Kangaroo Bay Hotel

Architectural Overview for TPC Hearing

9:30am, Tuesday 4th August 2026

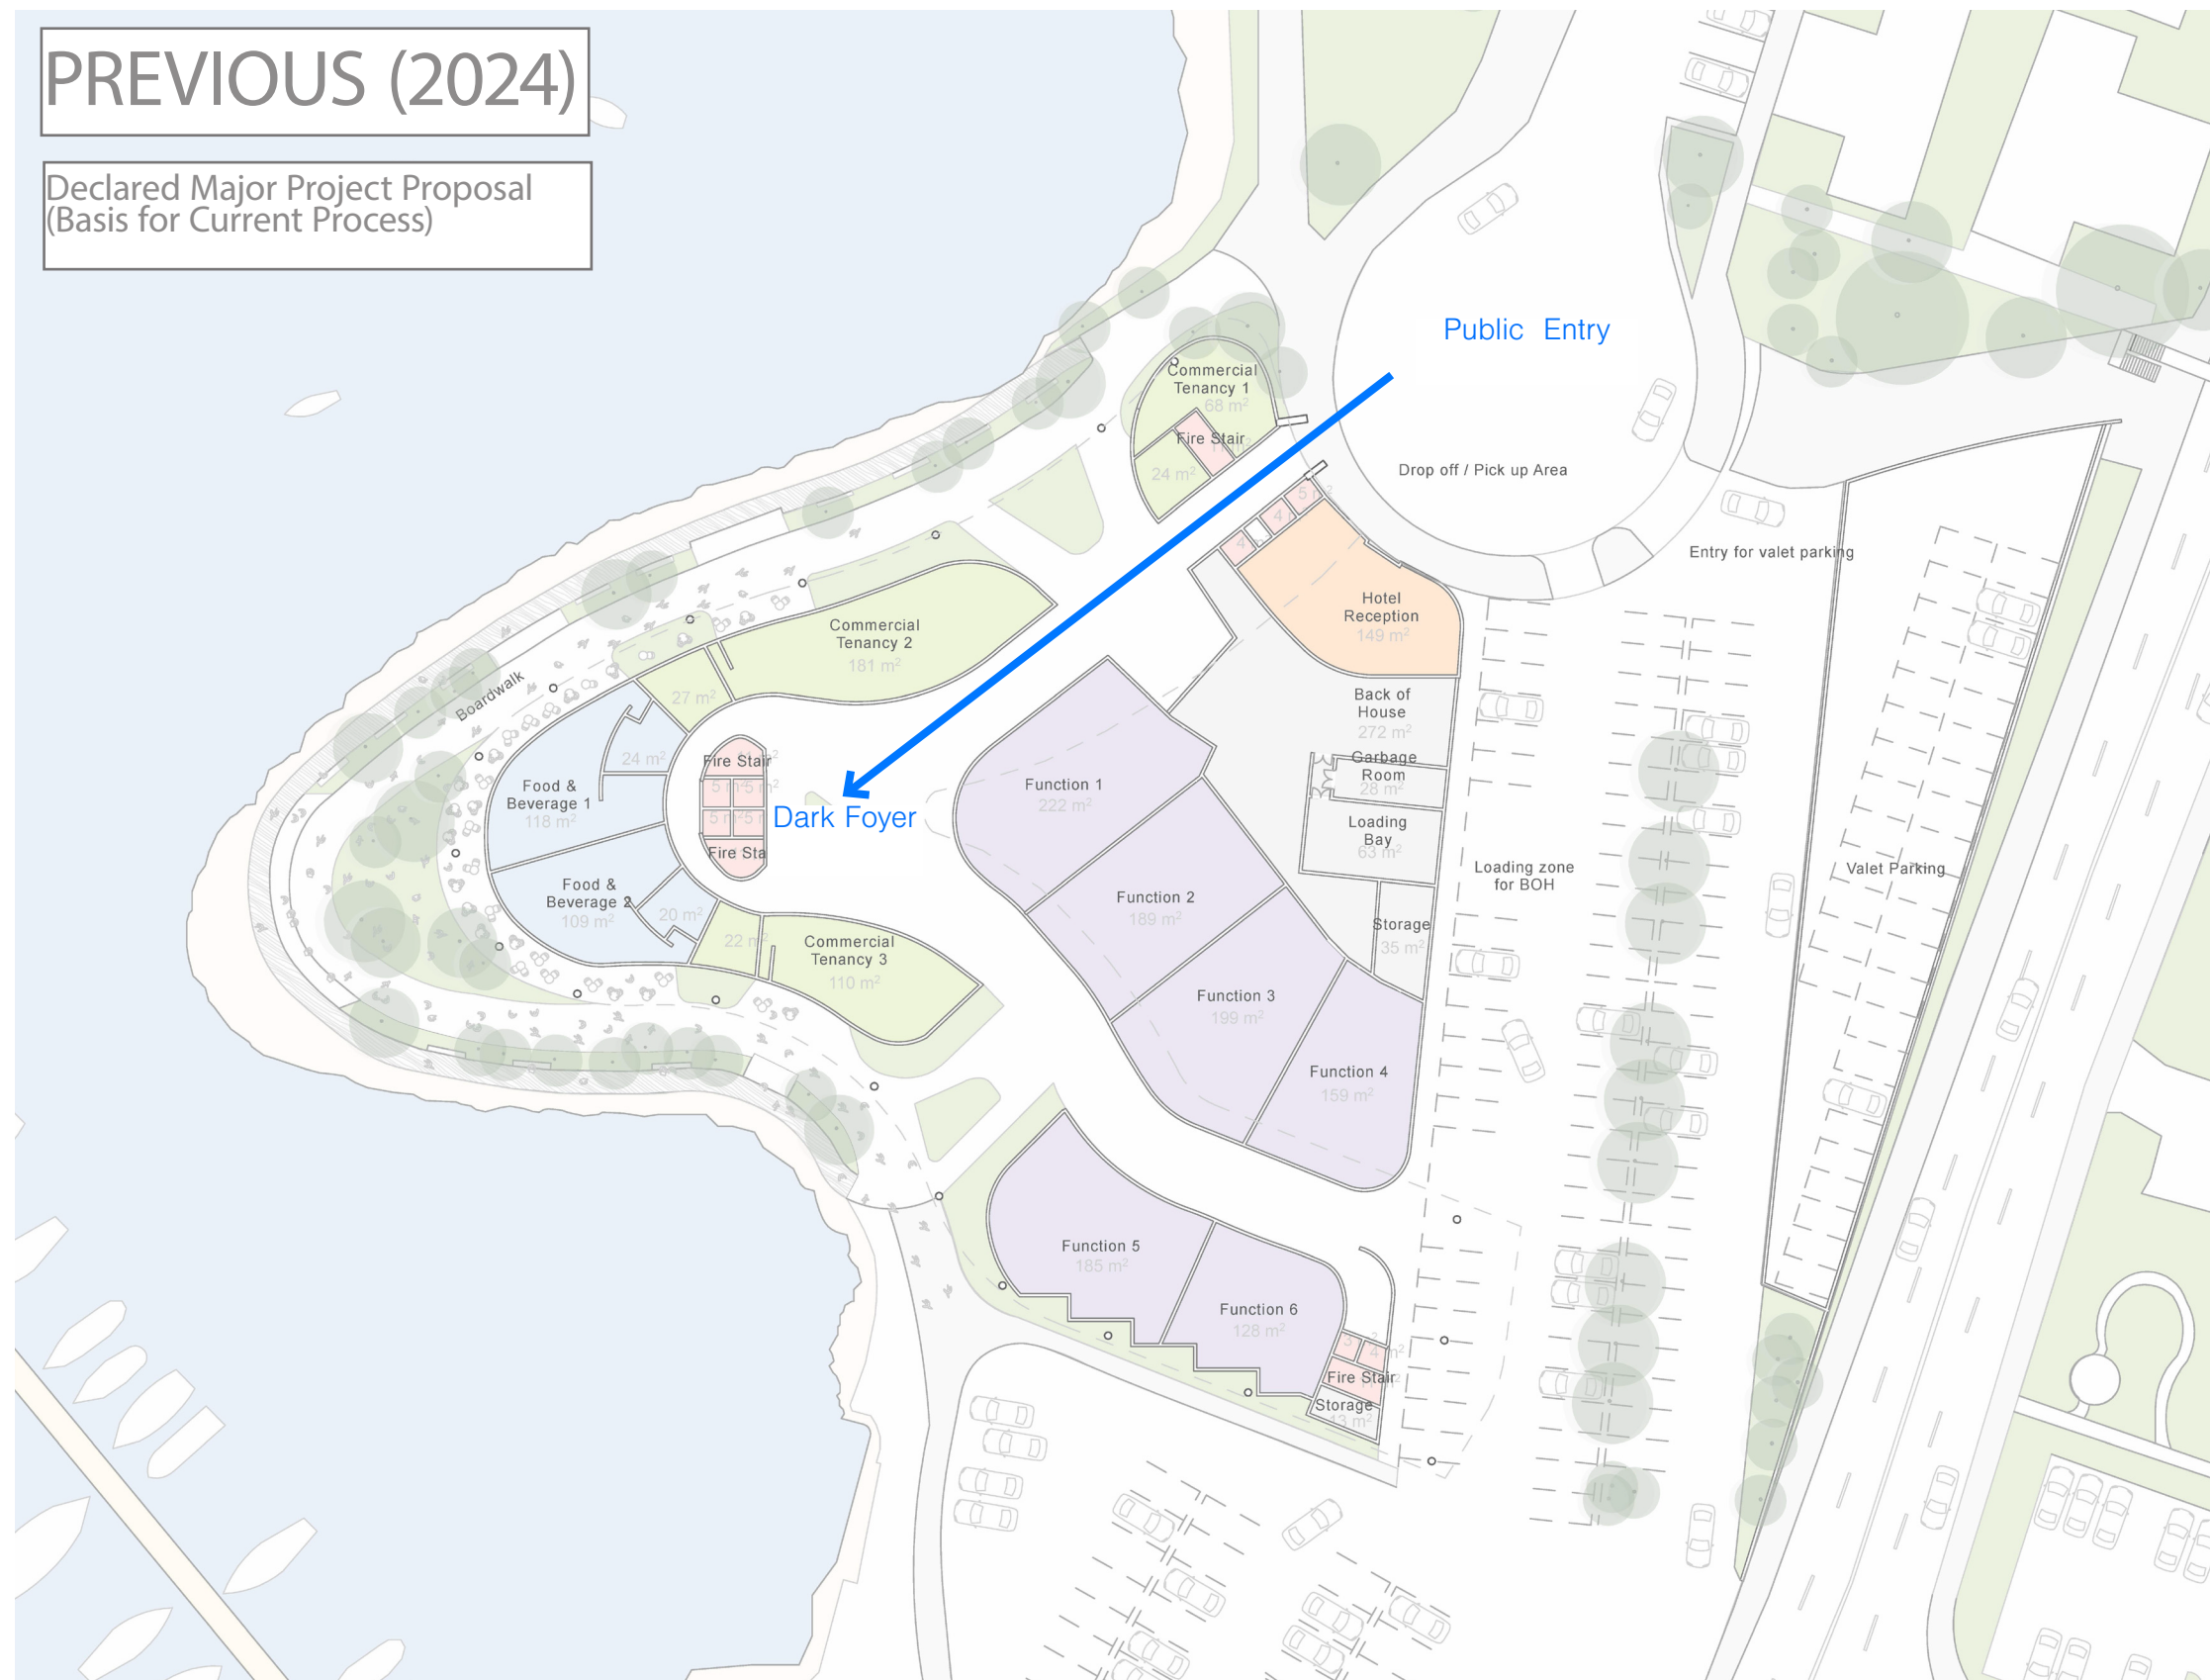
“1.3.1 The connection to Timtumili Minanya/River Derwent and Kunanyi/ Mount Wellington is demonstrated via montages showing view lines from inside the building, but not in the context of the surrounding environment.”

The Kangaroo Bay Hotel has been positioned and oriented at 101.42° in response to the surrounding topography, waterfront and key view corridors toward Kunanyi / Mount Wellington and Timtumili Minanya / River Derwent. The building geometry and ground-floor layout were developed using an accurate 3D terrain model and cross-checked against satellite imagery, ensuring that site connections, internal planning and major public spaces respond directly to the surrounding environment.

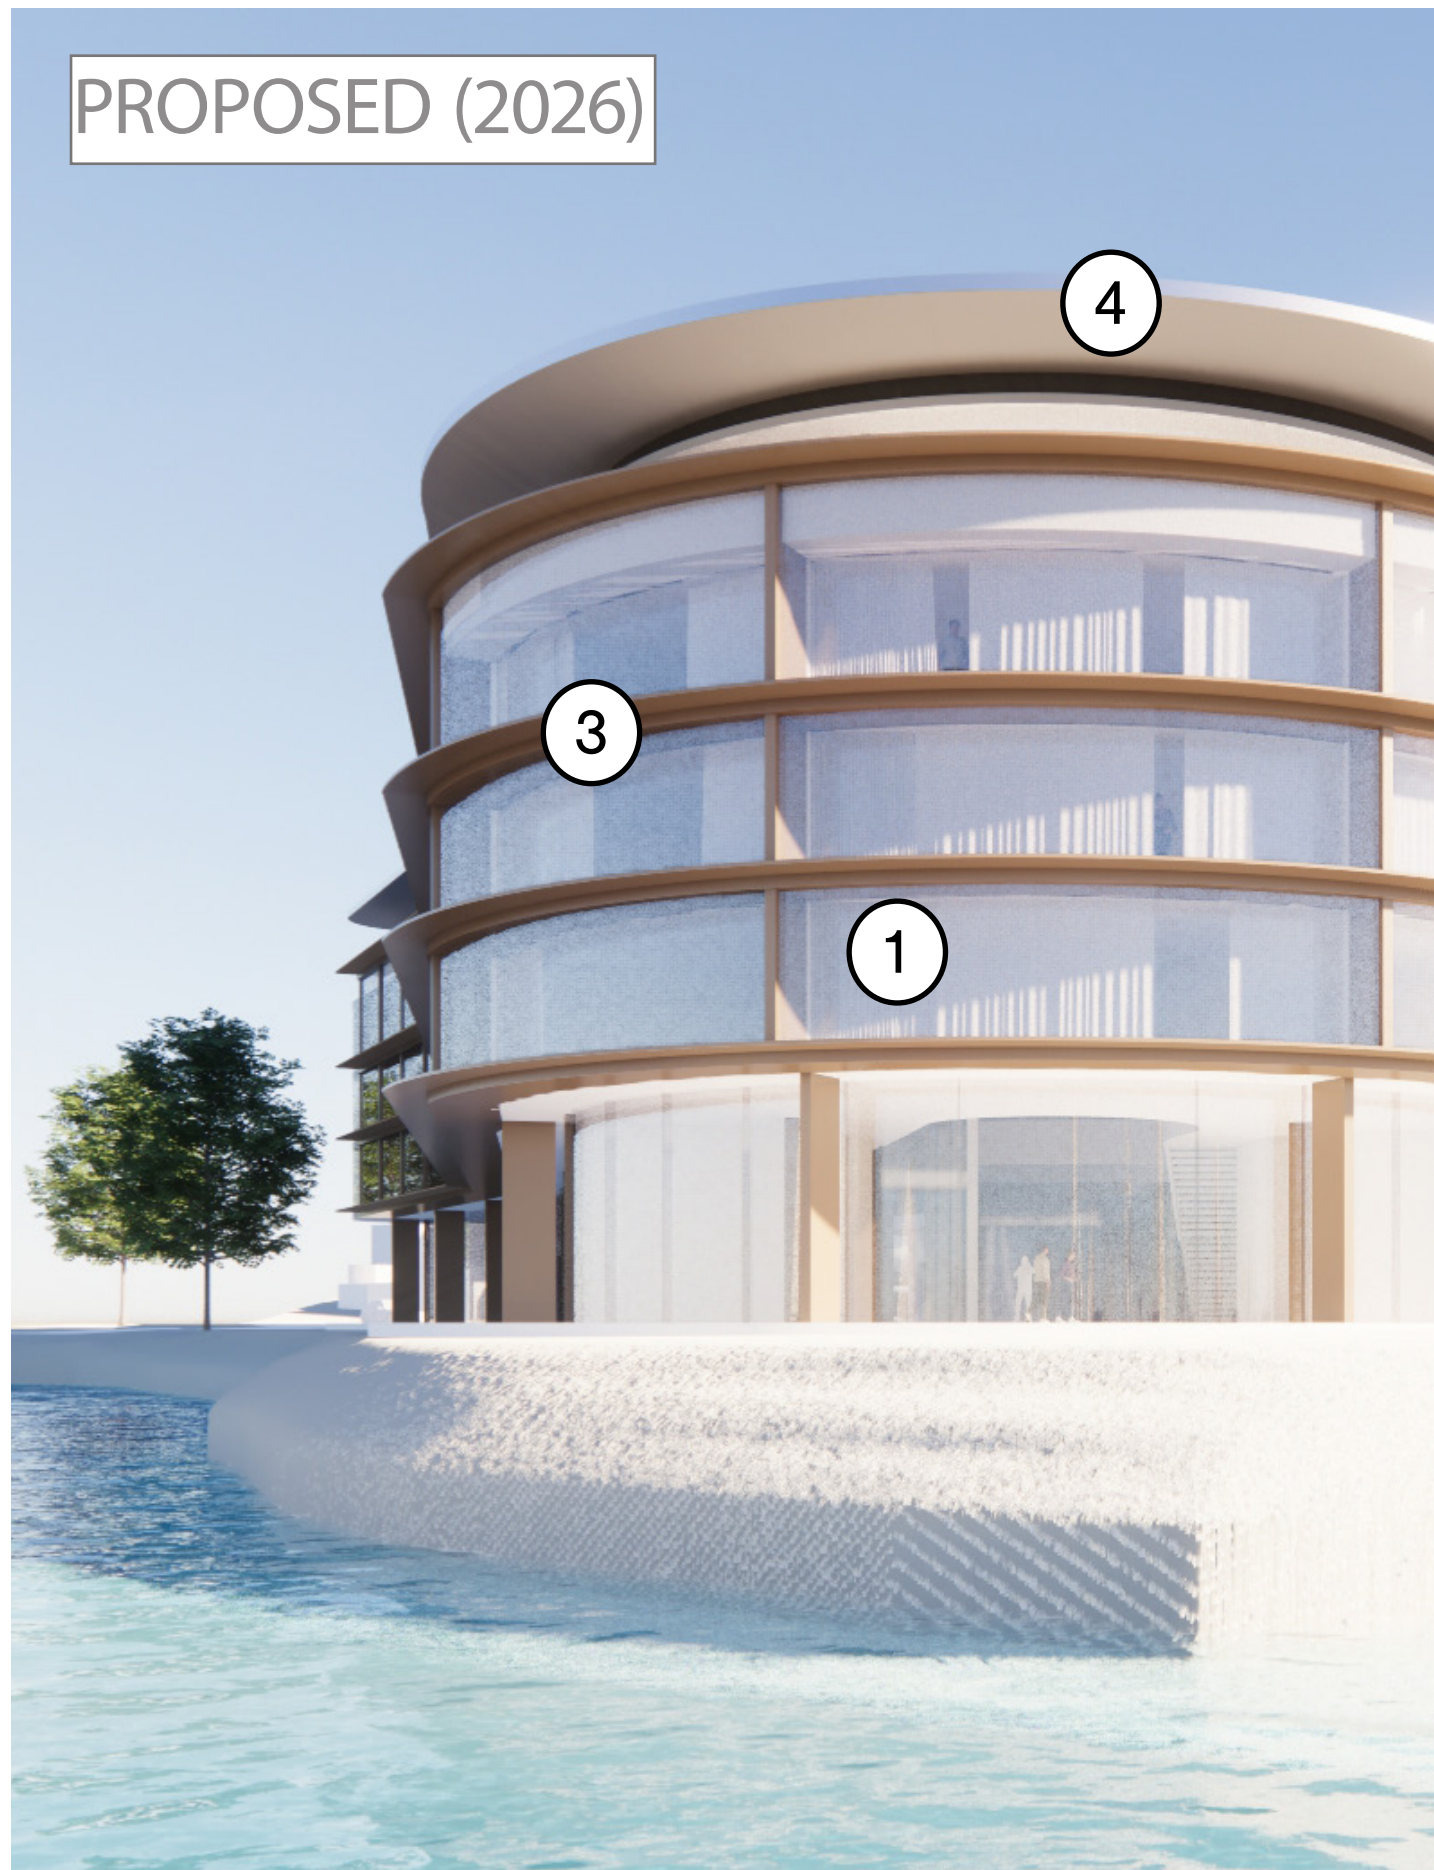
“1.2.1 The palette of proposed materials and their colour scheme provides limited details.”

“1.3.3 The architectural plans provide a preliminary external material schedule including glass, timber look cladding, concrete and metal cladding. The specifications of the proposed materials are not provided, limiting information on the Project’s visual response to the surrounding environment.”

In response, a detailed materials specification has been provided, defining the proposed palette, colours, finishes, performance requirements and construction detailing required to document the material selections.
